Update Note:

Stellantis Engine 1.5l BlueHDi DV5 YH

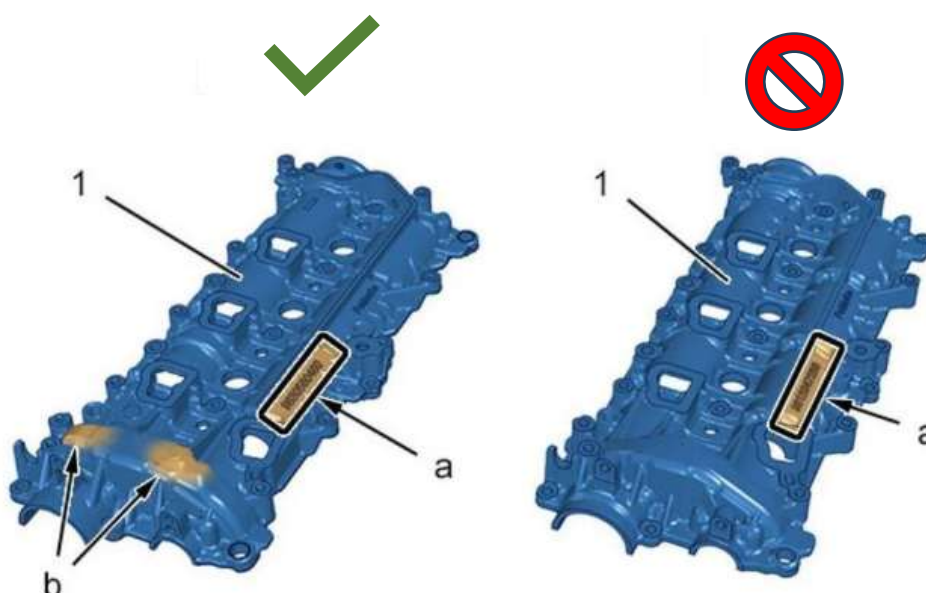
In the 1.5 BlueHDi engine developed by Stellantis in 2019, critical issues may be encountered due to premature wear of the timing chain, a chain which, if not replaced when excessive noise occurs can break, causing extensive damage to the engine. Aware of the problem, Stellantis technicians have made significant changes to the engine since January 2023, with the adoption of an 8 mm timing chain instead of 7 mm, new camshafts and a new valve cover. To recognize the pre-modified version, it is necessary to analyze the valve cover: the updated version has two small protuberances (b) and a rounded design around the shafts (1) as highlighted in the drawing below. The original reference number has also changed: 98 305 804 80 (a).
